REPORT TO CITY OF VISALIA PLANNING COMMISSION

HEARING DATE: October 28, 2013

SUBJECT: **North Sierra Estates Tentative Subdivision Map #5549:** A request by Edmond and Mary Cooper, property owners (Bob Ausherman, applicant) to subdivide 5.72 acres into 22 lots for single-family residential use in the R-1-6 (Single-family residential, 6,000 sq. ft. minimum lot size) zone. The site is located south of the intersection of Douglas Avenue and Tracy Street approximately 2,200 feet east of Ben Maddox Way. (APN: 098-050-069)

Exhibit "A"

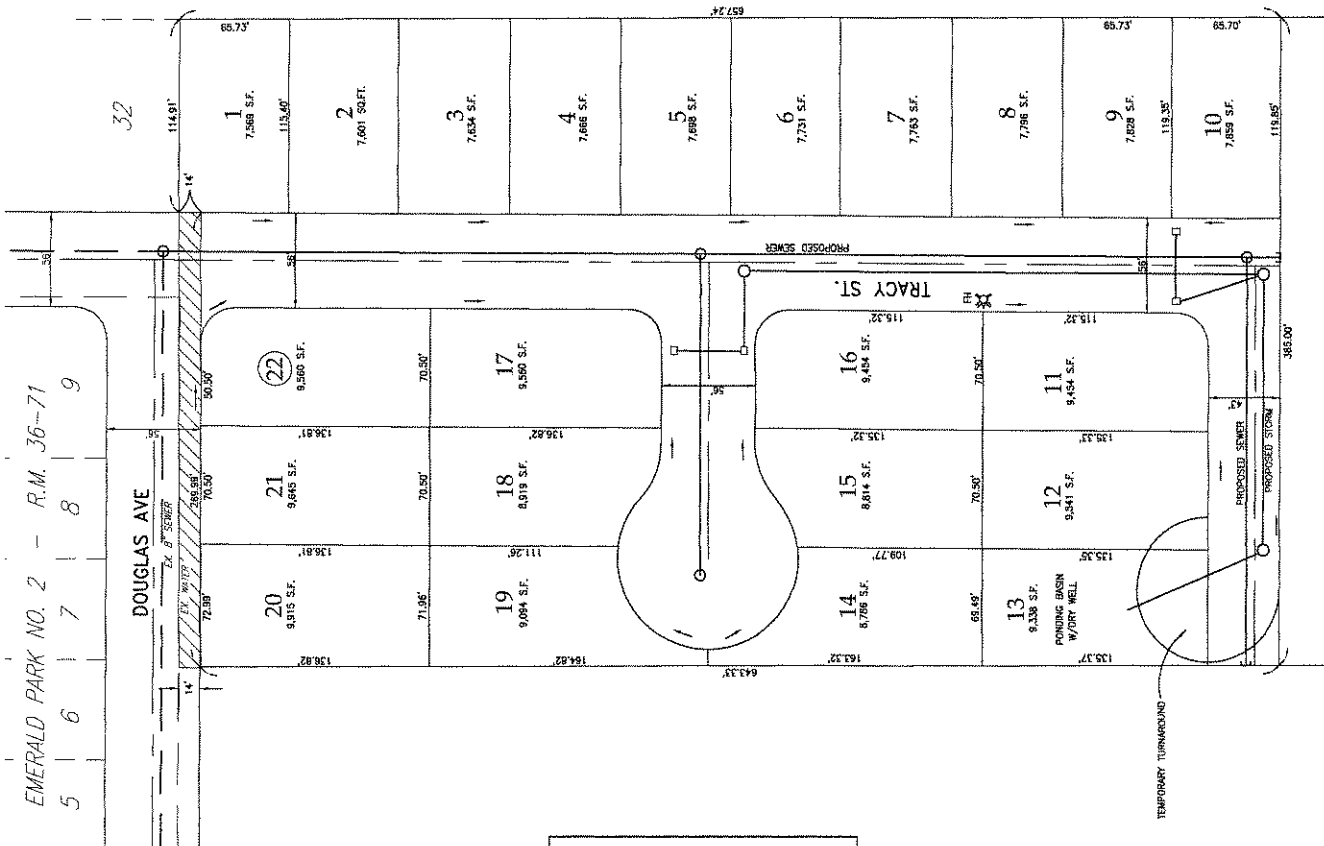
1. The redesigned subdivision map complies with staff's comments from August 07, 2013.
2. Design the local street, south of lots 11 thru 13, to accommodate an overall width of 43-feet.
3. Provide net acreage on the tentative subdivision map.

2. Staff will request a block wall be constructed pursuant to City Standards for Landscape and Lighting Lots along the north property lines of Lots 20, 21 & 22. The block wall shall continue south along the east property line of Lot 22. Depict the block wall and landscape and lighting lot on the revised subdivision map.

3. Staff is recommending that one of the cul-de-sacs be removed and designed to accommodate a future street connection with the property to the west.
4. Provide lot dimensions for all proposed lots within the subdivision.

1. Provide a seven-foot high concrete block wall along Lots 20, 21 & 22. The block wall shall continue south along the east side of Lot 22. The block wall shall be located behind the Landscape and Lighting Lot created along these lots including the east side of Lot 22.
2. NOTE: The maximum height of block walls and fences is 7-feet in the appropriate areas; this height is measured on the tallest side of the fence. If the height difference is such that the fence on the inside of the project site is not of sufficient height, the fence height should be discussed with Planning Staff prior to the filing of applications to determine if an Exception to fence/wall height should also be submitted.
